COUNTY ROAD 595 STREAM CROSSINGS

MARQUETTE COUNTY, MICHIGAN

REVISIONS THIS SET:

- SHEETS ADDED WTAS, W1AP,W1S, W1P, W2S, W2P, 17S AND 17P
- SHEETS OMITTED 2S, 2P, 3S, , 4S, 4P, 12S, AND 12P
- SHEETS REVISED A1, 1S, 1P, 1AS, 1AP, 5S, 6S, 6P, 7S, 7P, 8S, 8P, 9S, 9P, 10S, 10P, 11S, 11P, 13S, 13P, 14S, 14P, 15S, 15P, AND 16S

STREAM BOX CULVERT D60 UNNAMED TRIBUTARY TO MULLIGAN CREEK STA 1522+93

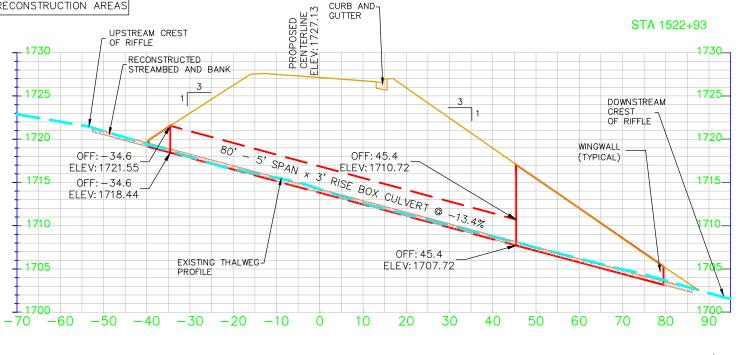
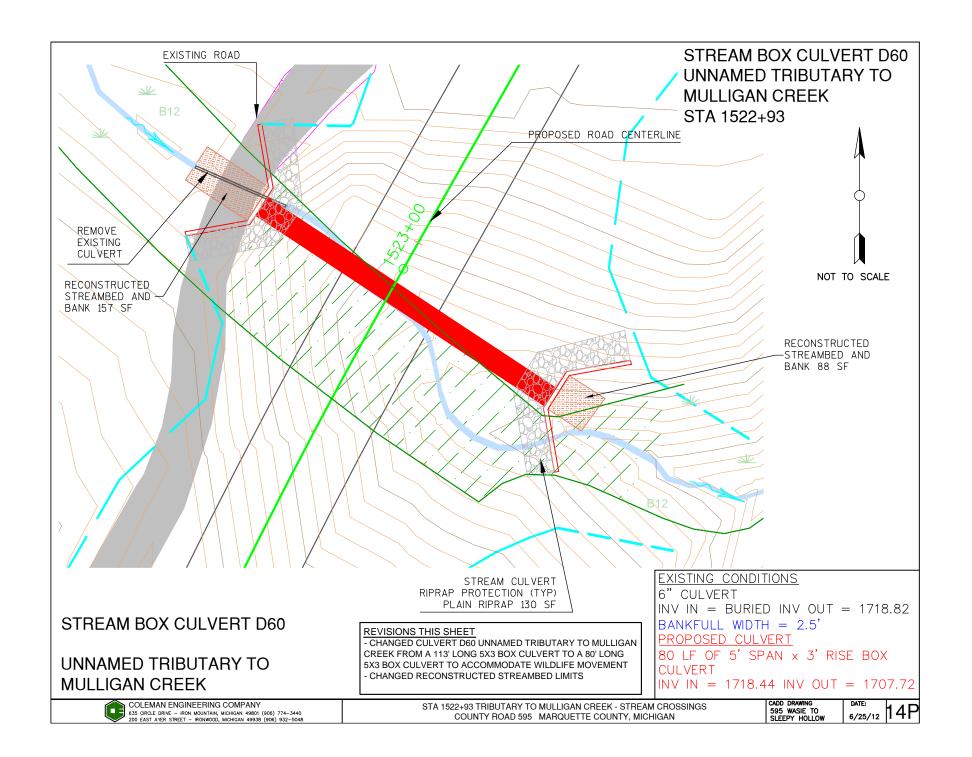
- CHANGED CULVERT D60 UNNAMED TRIBUTARY TO MULLIGAN CREEK FROM 113' LONG 5'X3' BOX CULVERT TO A 80' LONG 5'X3' BOX CULVERT TO ACCOMMODATE WILDLIFE MOVEMENT - ADD MAINTAINING BANKFULL WIDTH NOTE

STREAM BOX CULVERT D61 **UNNAMED TRIBUTARY TO** MULLIGAN CREEK STA 1527+21

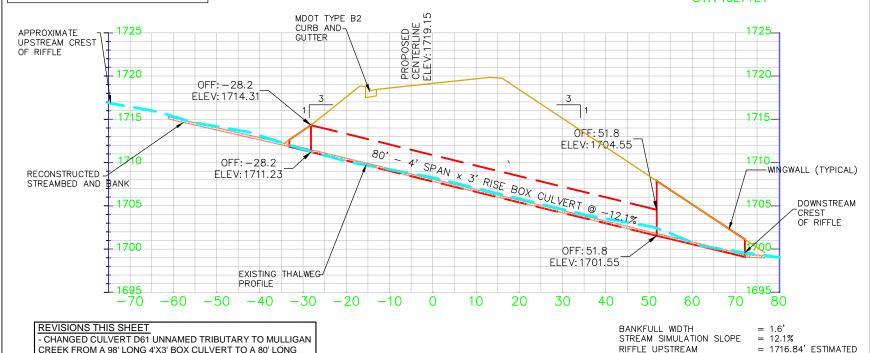
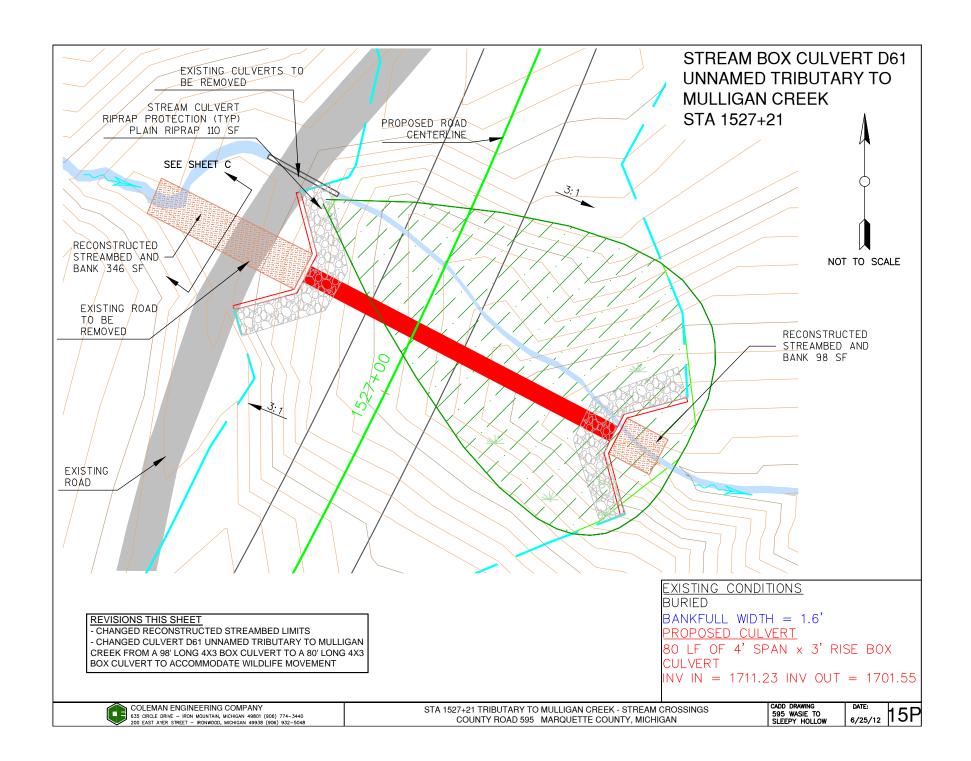
4'X3' BOX CULVERT TO ACCOMMODATE WILDLIFE MOVEMENT

STREAM BOX CULVERT D65A MULLIGAN CREEK STA 1564+25

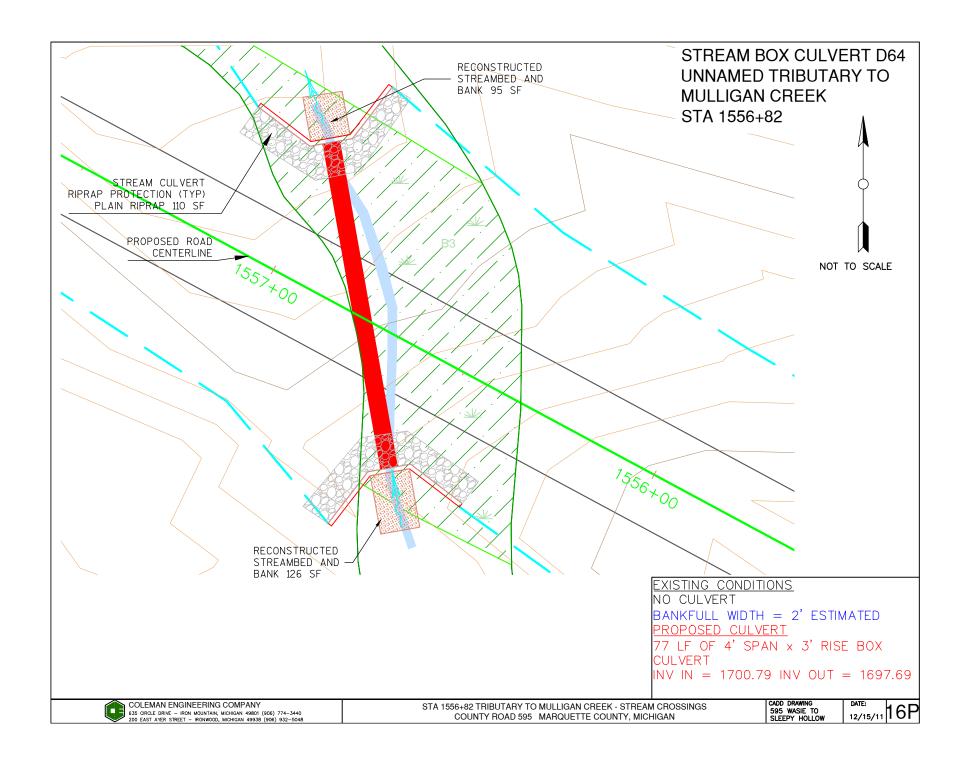
- ADD CULVERT D65A NEAR MULLIGAN CREEK, A 75' LONG 8'X4' BOX CULVERT. THIS LOCATION WAS IDENTIFIED DURING FIELD SITE VISIT JUNE 11, 2012
